Service Bulletin

Subject: A/C Blows Warm Air, A/C Inoperative, Automatic Transmission Cooler Bracket Contacting Condenser

Models: 2012-2013 Chevrolet Impala (Police Vehicle)
Equipped with 9C1 or 9C3

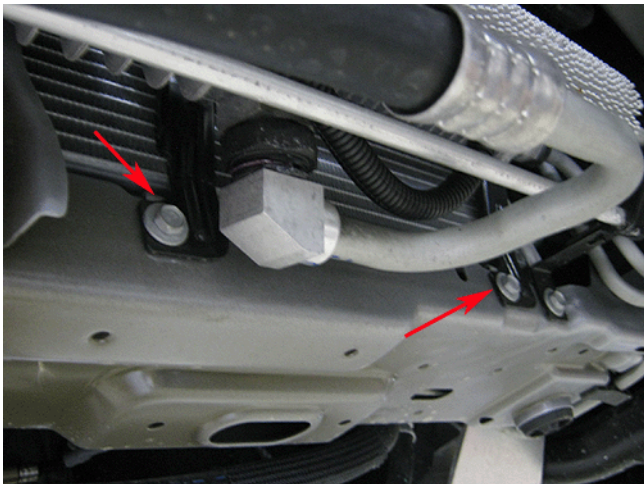
This may be caused by the transmission oil cooler bracket contacting the A/C condenser and rubbing through, resulting in a refrigerant leak.

Replace the condenser and adjust the automatic transmission oil cooler brackets (reposition at locations shown and/or install 1/8" shims) for clearance away from the A/C condenser. Refer to Air Conditioning Condenser Replacement in SI.
